Well Name: ZACHRY	Well Location: T29N / R10W / SEC 33 / NENW / 36.687347 / -107.892059	County or Parish/State: SAN JUAN / NM
Well Number: 29	Type of Well: CONVENTIONAL GAS WELL	Allottee or Tribe Name:
Lease Number: NMSF080724A	Unit or CA Name:	Unit or CA Number:
US Well Number: 3004525503	Operator: HILCORP ENERGY COMPANY

Notice of Intent

Procedure Description: Hilcorp Energy Company requests to REVISE the NOI for the Fruitland Coal recomplete approved on 6/17/2024. The revised perforations are listed in the updated procedure attached.

HILCORP ENERGY COMPANY
Zachry #29
FRUITLAND COAL RECOMPLETE SUNDRY
API 3004525503

Zachry #29 - PROPOSED WELLBORE SCHEMATIC

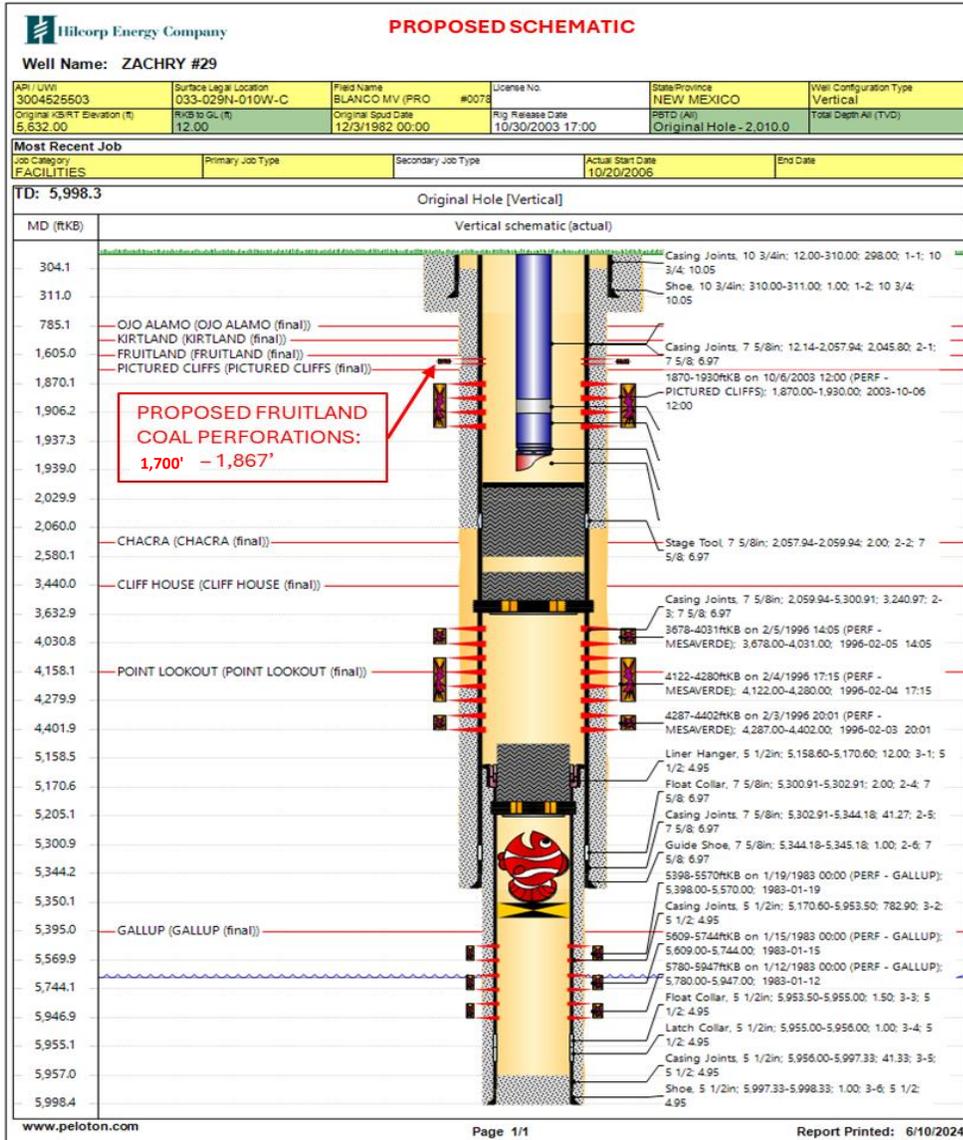
6. **If frac'ing down casing:** pressure test casing to frac pressure.
7. RU WL. Perforate the **Fruitland Coal**. Top perforation @ **1,700'**, bottom perforation @ **1,867'**.
